To: Durham Planning Board, Michael Behrendt

From: Gail Kelley, 11 Gerrish Dr., Durham

RE: Compliance with court ruling in Kelley v. Durham

Possible road-from Bagdad Rd. ROW

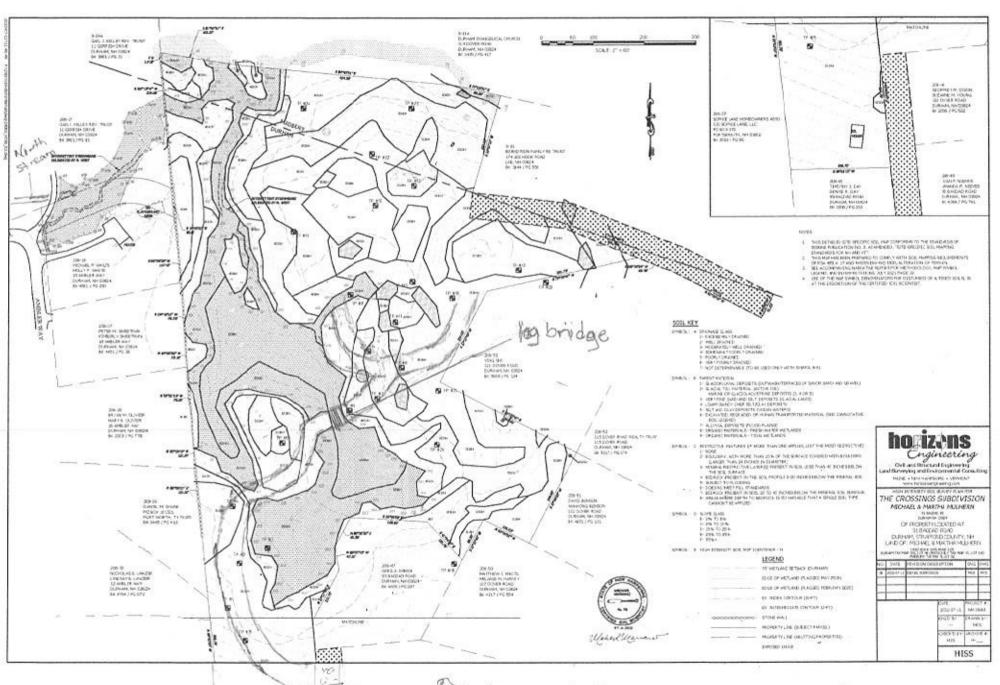
The HISS map tells a very different story about the Mulhern property. See below.

(Spoiler alert: Everything – EVERYTHING – outside the delineated wetland is non-wetland AND suitable for building a road. I'm not making this up. It's all in Michael Mariano's Soil Report and on the HISS map.)

If subsurface wastewater disposal, i.e., septic systems are allowed in 353 and 453 soils, then certainly these soils can support structures *on* the surface, such as, a bridge, culvert, or ROAD.

The areas in the north where the proposed house sites will be located are all 353.

With the exception of a few units of 321 or 324 soils and one 221, which are even drier than 353 because they consist of glacial till, ALL of the map units outside of the delineated wetlands are 353 or 453 soils. And 353, the soil where the house sites will be, is by far the most prevalent soil type throughout the property. So, a road from the south to the north would have only two minimal encounters with wetland and NO DESTRUCTION OF WETLAND. (Attached is a copy of the HISS map with such a road drawn from the Bagdad Rd. access point in the south to the subdivision house sites in the north.)
